NAEGELE RESIDENCE
70 Middle Rd
Palm Beach, FL 33480

RE: 4.A LANDSCAPE: STAFF COMMENTS

70 Middle Road: 6 Variances

JN: PROPOSED SITE PLAN & ROOF PLAN
70 MIDDLE ROAD, PALM BEACH, FL 33480

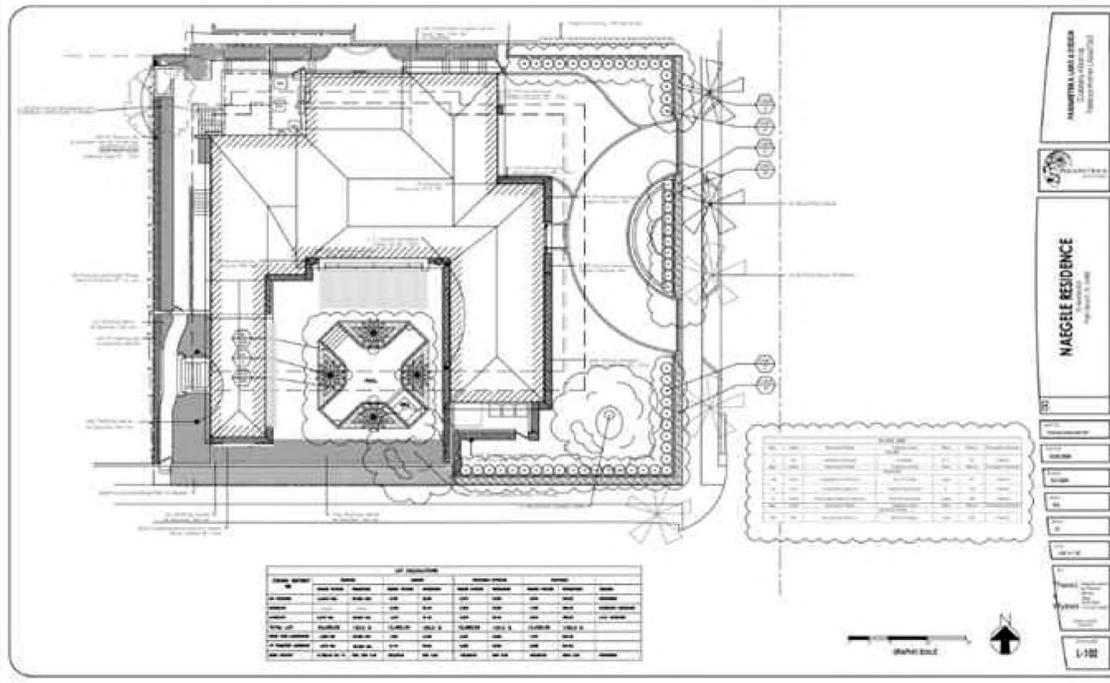
70 Middle Road – Complies (except for the existing Ficus to remain)

There is an existing Ficus benjamina on the northwest property line noted to remain. We would highly recommend that this tree be removed.

**PROPOSED
SITE PLAN**

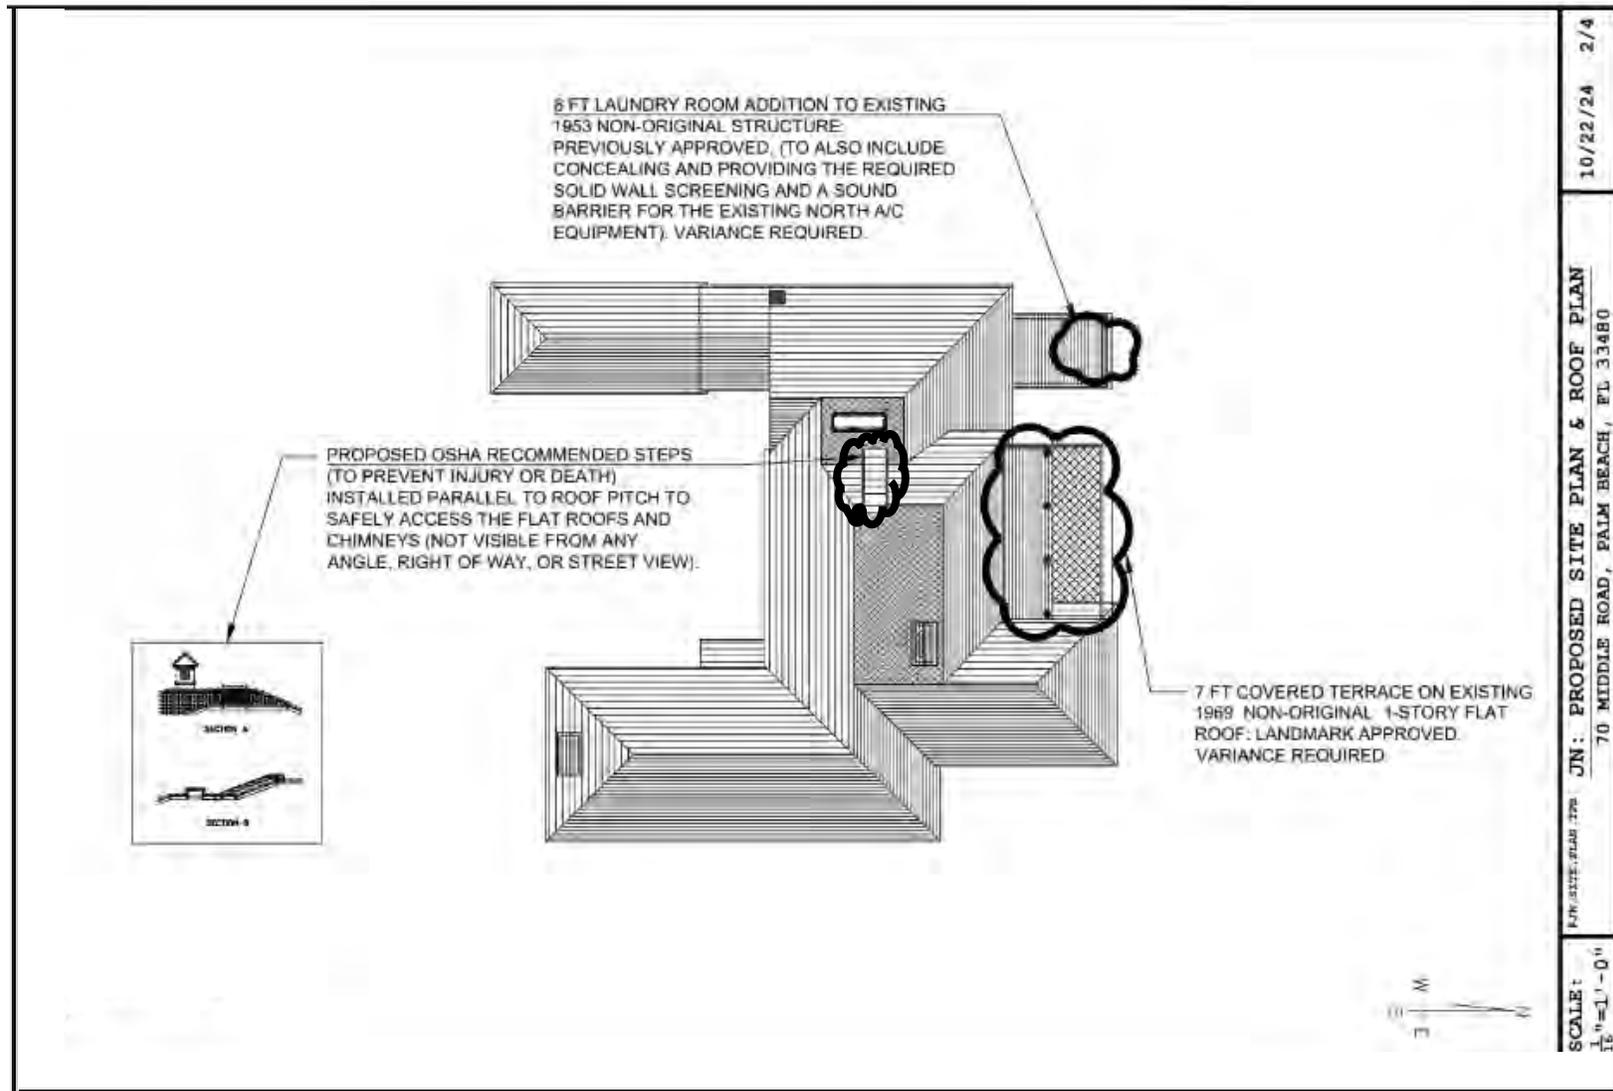
8 FT LAUNDRY ROOM ADDITION (TO 1953 NON-ORIGINAL STRUCTURE): LANDMARK APPROVED (TO ALSO INCLUDE CONCEALING AND PROVIDING THE REQUIRED SOLID WALL SCREENING AND A SOUND BARRIER FOR THE EXISTING NORTH A/C EQUIPMENT). VARIANCE REQUIRED.

ORIGINAL POOL EQUIPMENT LOCATION: EXISTING POOL EQUIPMENT WAS NOT SCREENED BY A SOLID WALL BECAUSE THE ORIGINAL SOUTH WALL HAS LARGE OPEN VOIDS (72" X 26") WHICH PROVIDED NO SOUND BARRIER FOR THE POOL EQUIPMENT.

PROPOSED RELOCATION OF POOL EQUIPMENT TO A LOCATION FARTHER FROM THE STREET AT A LOWER GRADE FOR NOISE REDUCTION. POOL, FOUNTAIN AND A/C EQUIPMENT TO BE ENCLOSED AND CONCEALED BEHIND PREVIOUSLY APPROVED SOLID SOUTH EQUIPMENT ENCLOSURE WALLS (PROVIDING THE REQUIRED SCREENING AND SOUND BARRIERS). VARIANCE REQUIRED.

PROPOSED FRONT YARD FOUNTAIN: INCORPORATE PORTION OF THE ORIGINAL FRONT FOUNTAIN; TO CREATE WATER FEATURE DESIGNED TO COMPLIMENT HALF CIRCULAR DRIVEWAY.

ENLARGED ROOF PLAN
SCALE: 1/2"=1'-0"

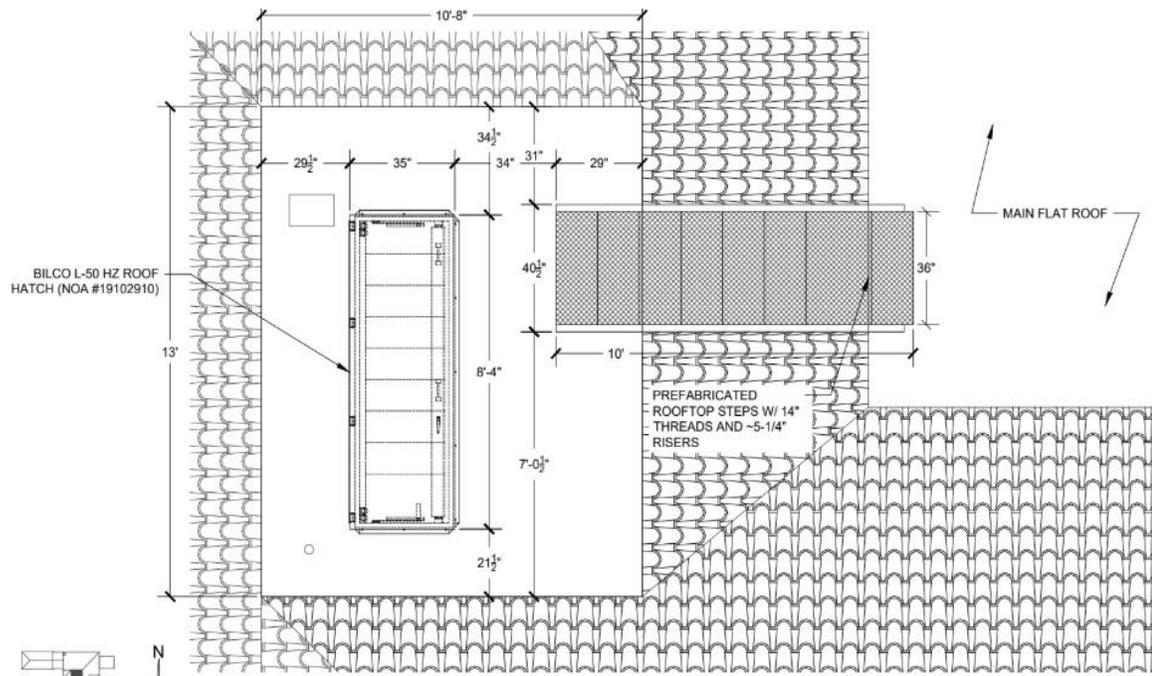
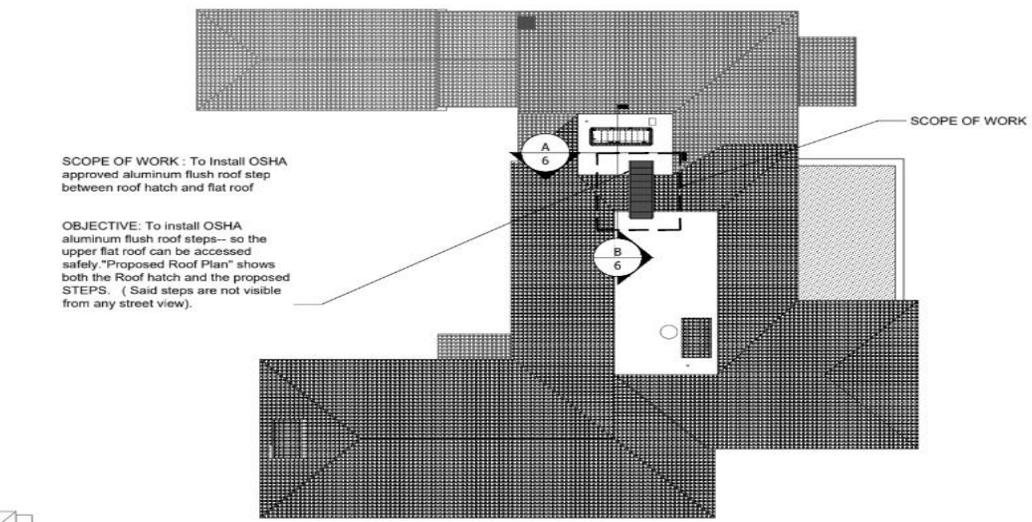
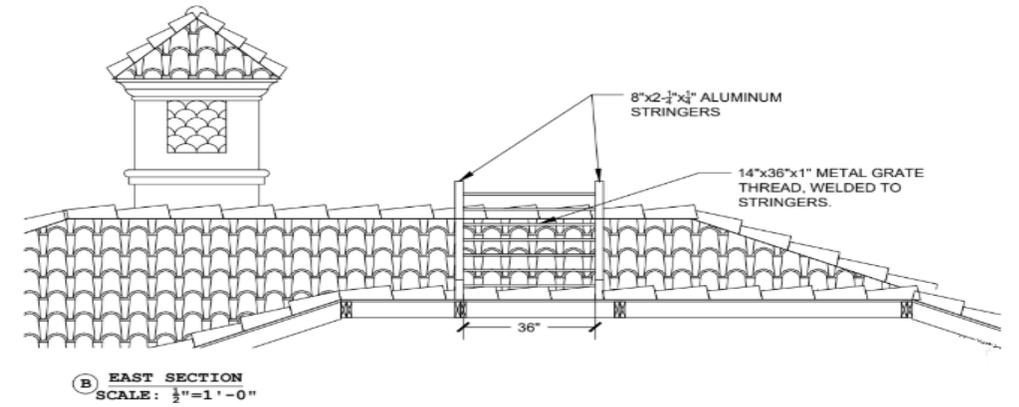
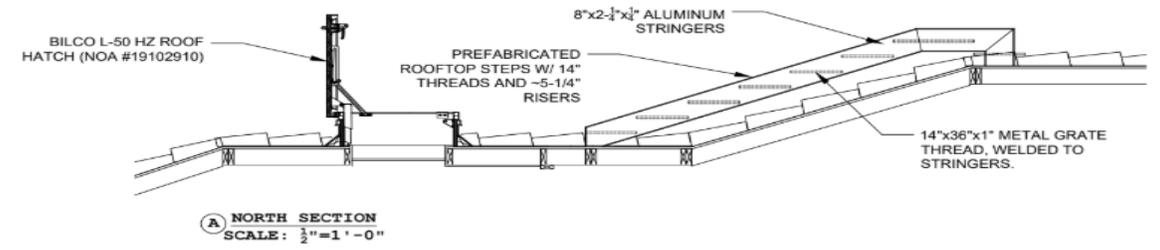
- 1) THE OSHA APPROVED STEPS ARE A SAFETY MEASURE SO THE OWNERS STAFF AND MAINTENANCE CREW DO NOT SUFFER CATASTROPHIC FALLS FROM THE ROOF WHILE PERFORMING VARIOUS MAINTENANCE AND/ OR ROOF REPAIRS.

- 6) THE OSHA APPROVED STEPS PROVIDE A SAFER AND MORE EFFICIENT ACCESS BETWEEN THE TWO FLAT ROOFS ; REDUCING THE NEED FOR LADDERS AND OTHER POTENTIALLY HAZARDOUS ACCESS METHODS TO TRANSITION BETWEEN THE TWO FLAT ROOF FOR CHIMNEY AND ROOF ACCESS.

- 7) THE OSHA APPROVED STEPS ARE NOT VISIBLE FROM ANY RIGHT OF WAY OR STREET VIEWS.
- 8) APPROVAL OF THE OSHA APPROVED STEPS WILL NOT CONFER ANY SPECIAL PRIVILEGE NOR WOULD THEY BE DETRIMENTAL TO THE PUBLIC WELFARE. HOWEVER, NOT INSTALLING THE OSHA APPROVED STEPS COULD RESULT IN INJURY OR DEATH; OF WHICH THE OWNER IS SEEKING TO AVOID 3RD PARTY LIABILITY.

PHOTOS SHOWING ROOF STEPS NOT VISIBLE FROM STREET OR RIGHT OF WAY

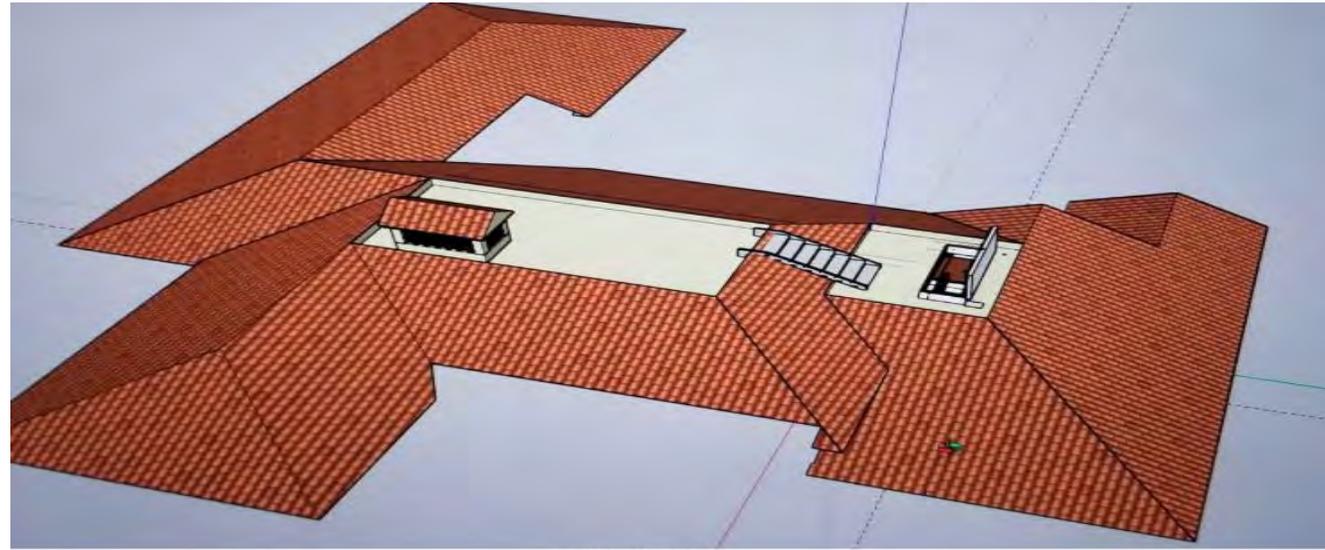
ROOF STRINGER STEPS NOT VISIBLE FROM STREET OR RIGHT OF WAY

7 FT COVERED TERRACE:
LANDMARK APPROVED BUT REQUIRES
A ZONING VARIANCE TO CONSTRUCT

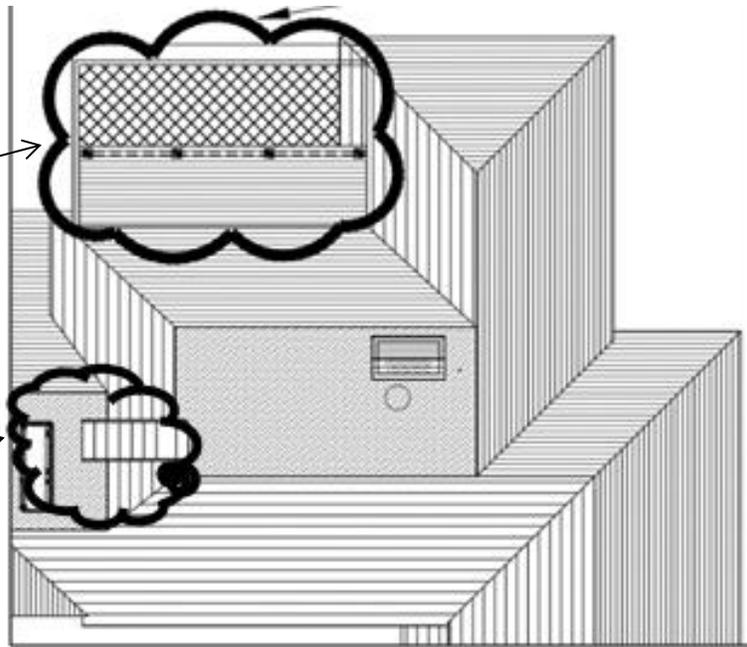
2. Section 134-893(b)(13): A variance to increase the cubic content ratio ("CCR") for the previously approved laundry room addition and previously approved covered terrace resulting in a Cubic Content Ratio of 8.59 in lieu of the 8.44 existing and the 3.95 maximum allowed under the Code.

3. Section 134-893(b)(7): A variance to reduce the side (North) yard setback for the previously approved laundry room addition and previously approved terrace railing addition (on an existing 1-story flat roof) resulting in a North side yard setback of 7.6 feet in lieu of the 12.5 foot minimum required under the Code.

4. Section 134-893(b)(10): A variance to increase building height of 27.4 feet in lieu of the 22 feet required under the Code for the previously approved 7-foot covered terrace (on the existing 1-story flat roof). Increase of overall building height for the OSHA recommended Rooftop steps resulting in 47.1 feet in lieu of the 30 feet required under the Code (13 inches higher than the existing 46 feet high flat roof).

8 FT LAUNDRY ROOM EXTENSION:
LANDMARK APPROVED BUT REQUIRES A
ZONING VARIANCE TO CONSTRUCT
(TO ALSO INCLUDE CONCEALING AND
PROVIDING SOLID WALL SCREENING AND
SOUND BARRIER FOR THE EXISTING NORTH
A/C EQUIPMENT).

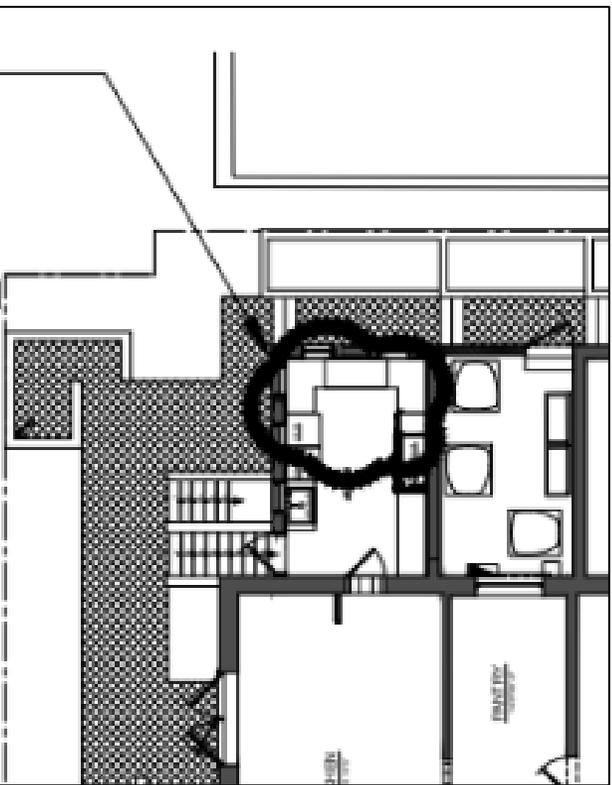
- 1. Section 134-893(b)(11): A variance to increase lot coverage for previously approved 8 foot laundry room addition resulting in lot coverage of 34.47% in lieu of the 33.07% existing and 30% maximum allowed under the Code.
- 2. Section 134-893(b)(13): A variance to increase the cubic content ratio (“CCR”) for the previously approved laundry room addition and covered terrace resulting in a Cubic Content Ratio of 8.59 in lieu of the 8.44 existing and the 3.95 maximum allowed under the Code.
- 3. Section 134-893(b)(7): A variance to reduce the side (North) yard setback for the previously approved laundry room addition and previously approved terrace railing addition (on an existing 1-story flat roof) resulting in a North side yard setback of 7.6 feet in lieu of the 12.5 foot minimum required under the Code.

ORIGINAL POOL EQUIPMENT LOCATION:
EXISTING POOL EQUIPMENT WAS NOT
SCREENED BY A SOLID WALL BECAUSE
THE ORIGINAL SOUTH WALL HAS
LARGE OPEN VOIDS (6' 6" X 26")
WHICH PROVIDE NO SOUND BARRIER
FOR THE POOL EQUIPMENT.

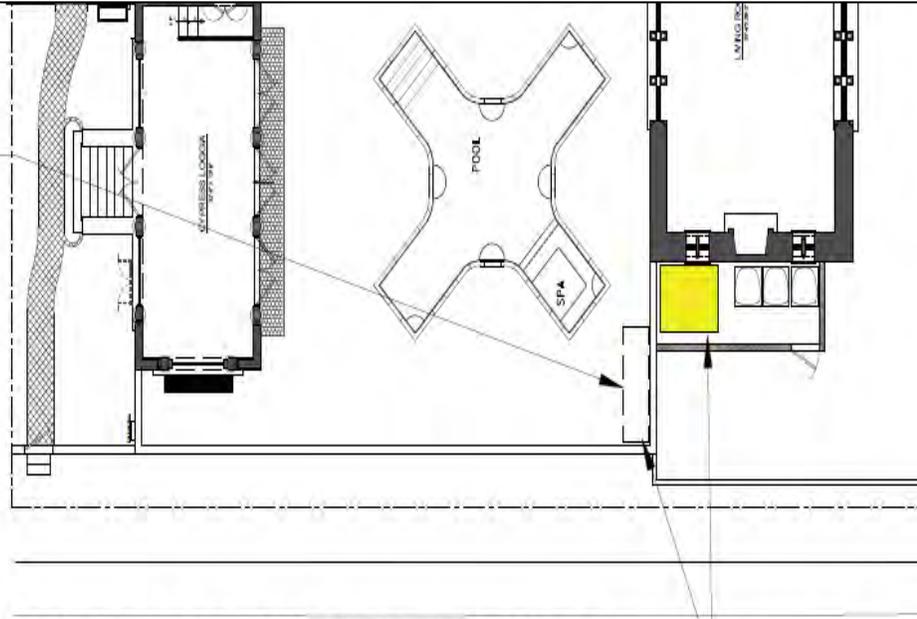
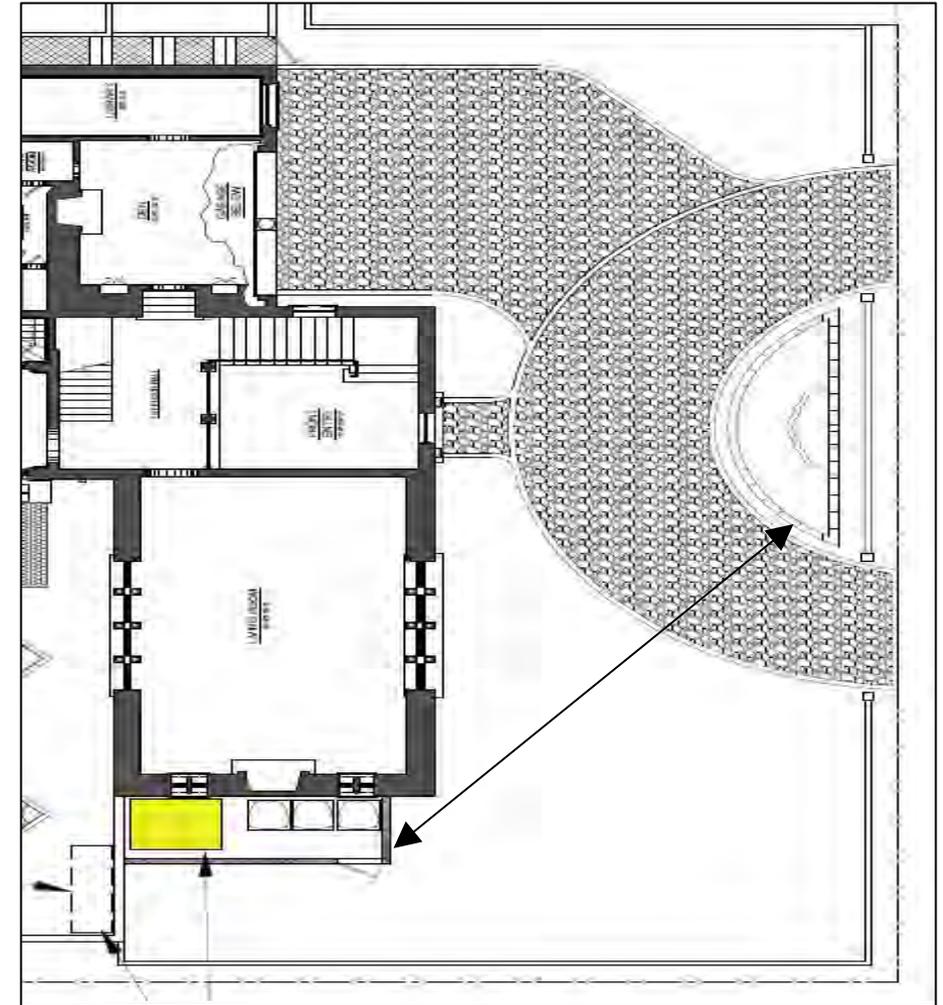
PROPOSED RELOCATION OF POOL EQUIPMENT TO A LOCATION FARTHER FROM THE
STREET AT A LOWER GRADE FOR NOISE REDUCTION. POOL, FOUNTAIN AND A/C
EQUIPMENT TO BE ENCLOSED AND CONCEALED BEHIND THE PREVIOUSLY APPROVED
SOLID SOUTH A/C ENCLOSURE WALL PROVIDING THE REQUIRED SCREENING AND SOUND
BARRIERS. VARIANCE REQUIRED TO CONSTRUCT.

5. Section 134-1728(c)(5): A variance to reduce the street (South) side yard setback of previously approved South equipment enclosure for existing pool equipment and fountain equipment resulting in a street side yard setback of 15.6 feet in lieu of the 20 foot minimum required under the Code. Increase the distance between the fountain's water's edge and the fountain equipment located 54.5 feet away from the water's edge in lieu of the 25 feet maximum allowed under the Code.

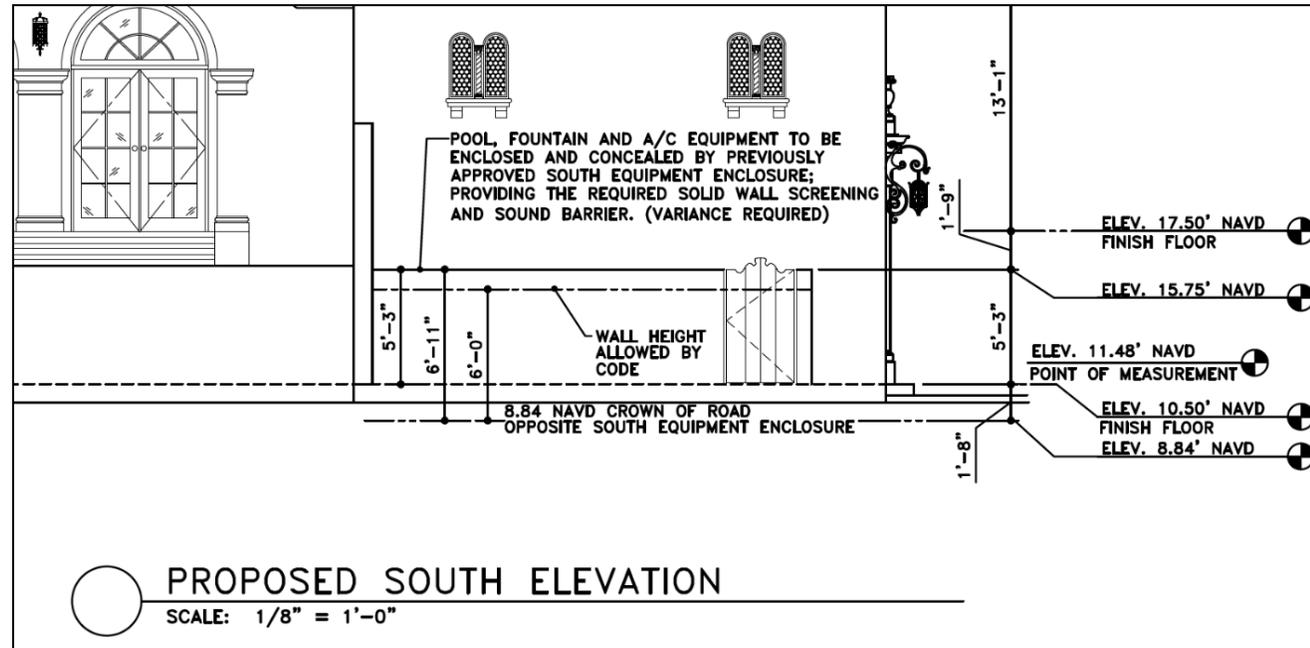
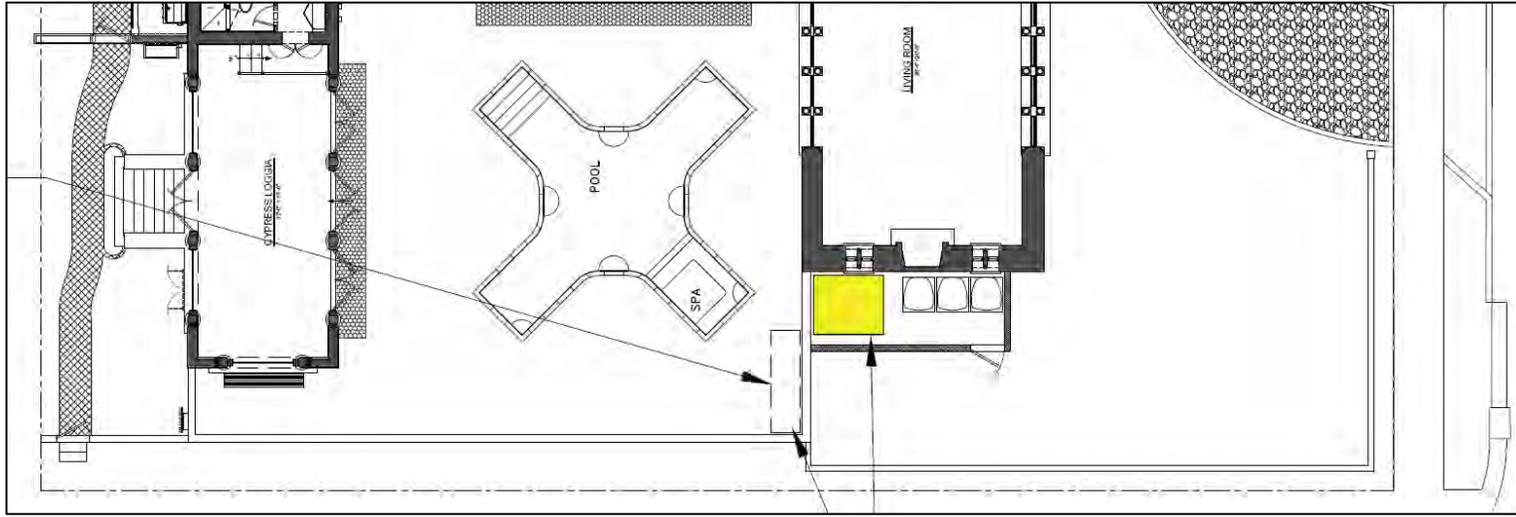
6. Section 134-1667(a): A variance to increase the height of the previously approved South equipment enclosure walls in the street (South) side yard setback to 6.9 feet in height in lieu of the 6 foot maximum allowed under the Code.
